Re: Mayflower Platinum – Requirement for utilities & services.

Note on Mayflower Platinum.

LEVELS

**REPORT ON GEOTECHNICAL INVESTIGATION FOR PROPOSED
CONSTRUCTION OF APARTMENT BUILDINGS FOR MAY FLOWER
PLATINUM PROJECT NEAR NOMA FUNCTION HALL, MALLAPUR,
MEDCHAL MALKAJGIRI DISTRICT**

Description		Direction	Owners & Developers :	Date :	Promoted by
EARTH FILLING PLAN		N	Project Name & Phase :	06.02.19	Modi Properties &
			May Flower Platinum	Prepared By :	Investments Pvt. Ltd.
				Approved By :	
				Scale :	Phone: +91-40-66335551

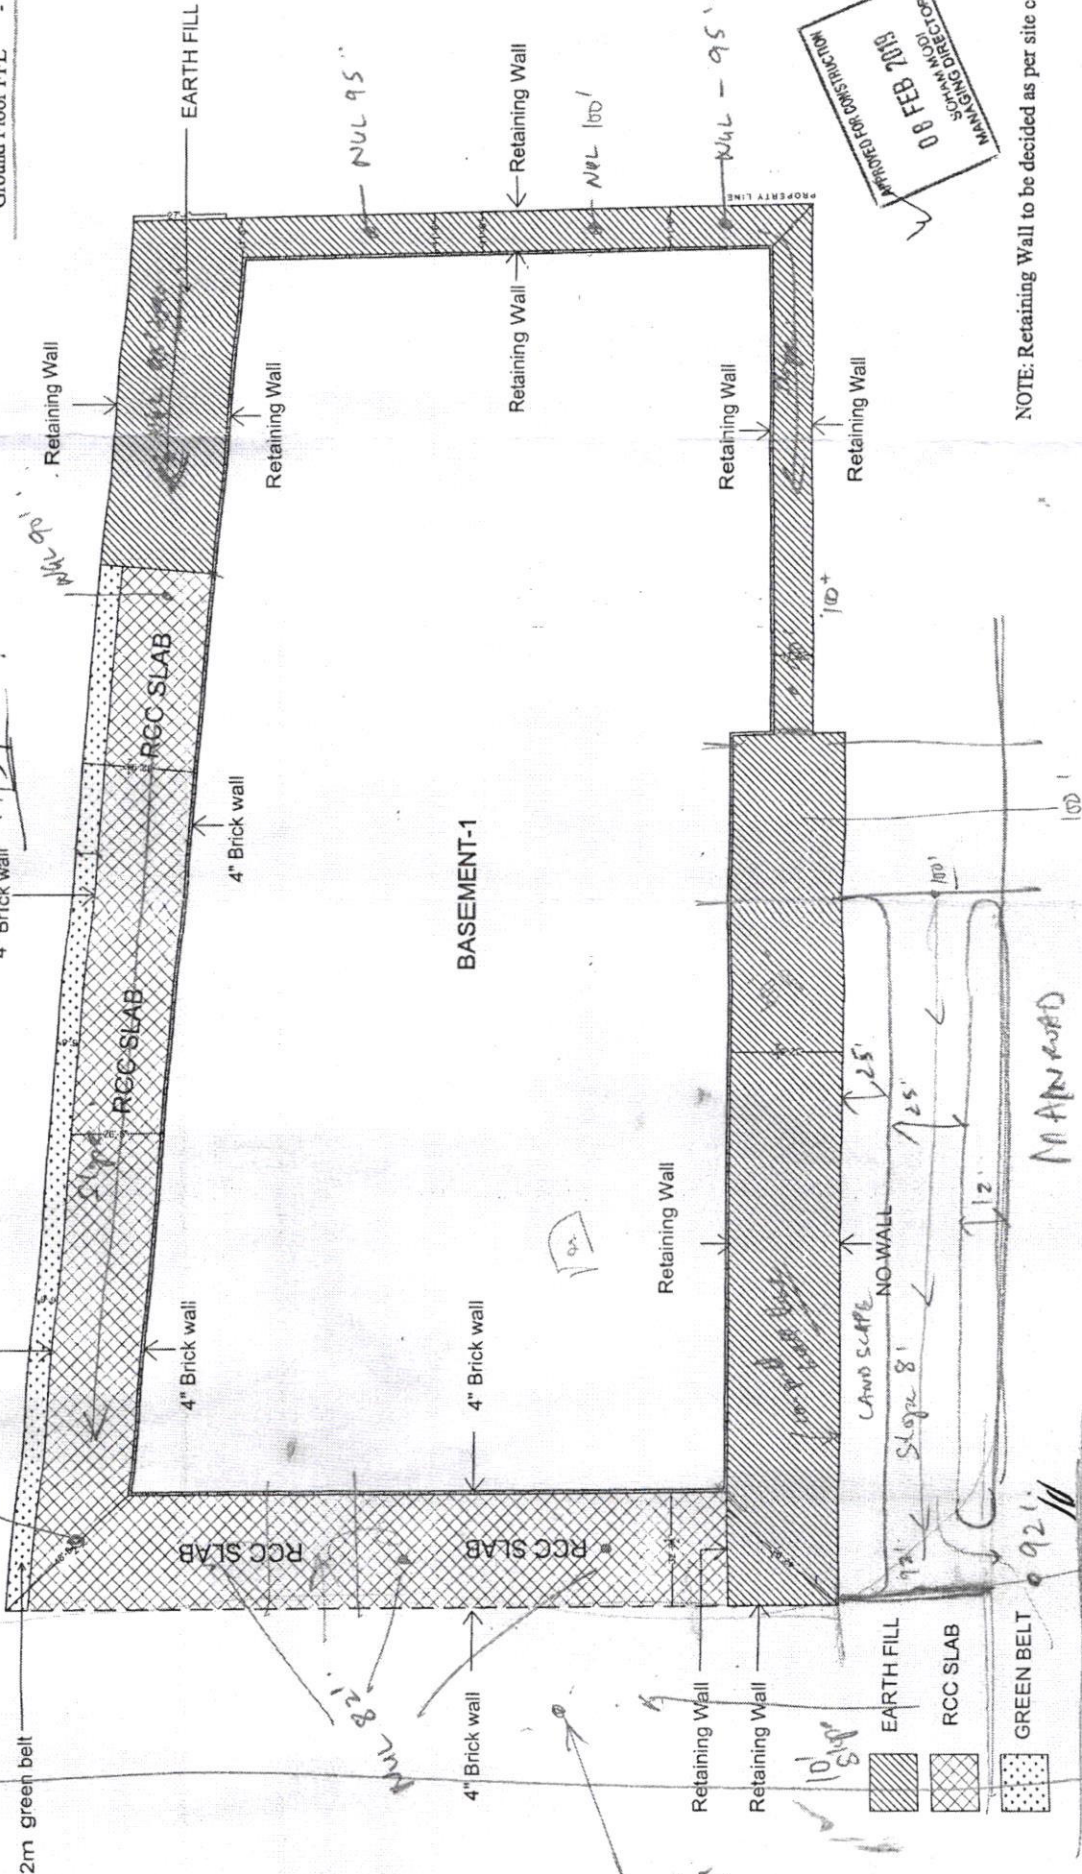
MODI AT SITE -

WITH SOHAM, DATTI ATERUP ROAD & R.M.

19/3/19

Lower Basement FFL - 80'
Upper Basement FFL - 90'
Drive Way FFL - 100'
Ground Floor FFL - 103'

NOTE: Retaining Wall to be decided as per site condition.
